**ADDENDUM NUMBER 2**

**BID/RFP TITLE: FURNISH & INSTALL STEAM BOILER AT NORTH QUINCY  
HIGH SCHOOL**

**Addendum #2**

"Exhibit B"

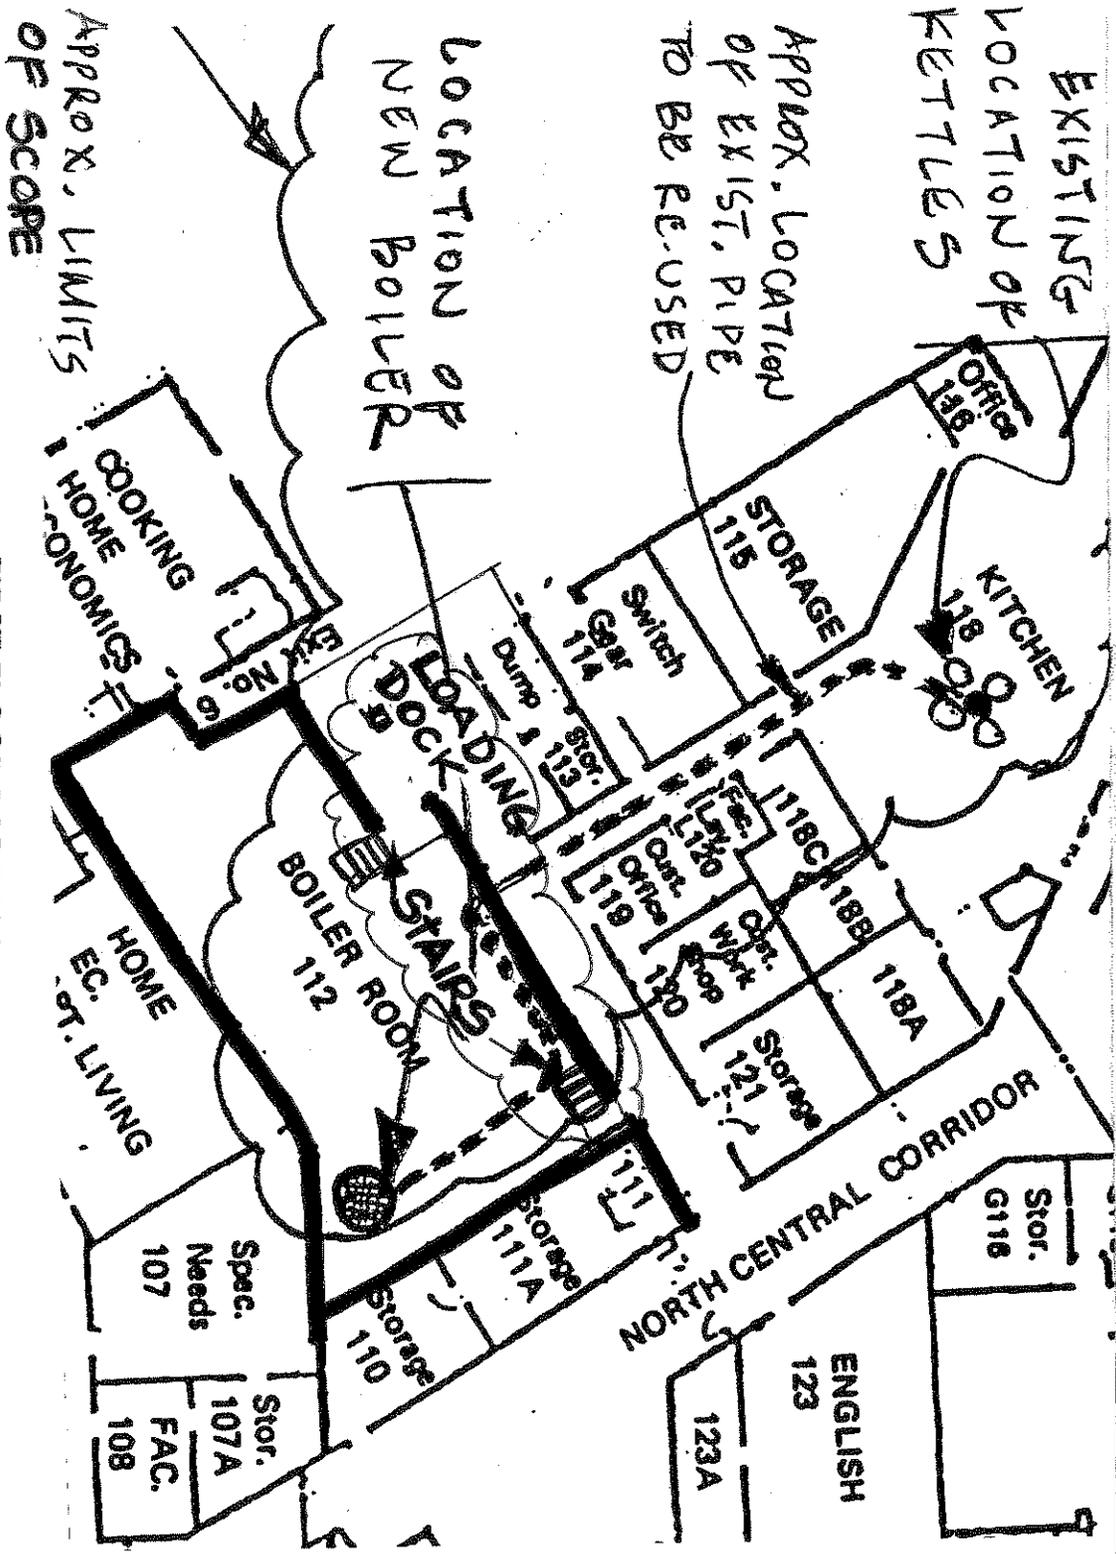
Question 6. What are the means of egress from the boiler room?

Answer 6 **There are two sets of metal stairs from the boiler room floor up to the first floor. One set of these stairs leads to an interior corridor and then to a loading dock. The second set of stairs leads directly out to the same loading dock. See the attached enlargement (Exhibit B) of the Plan.**
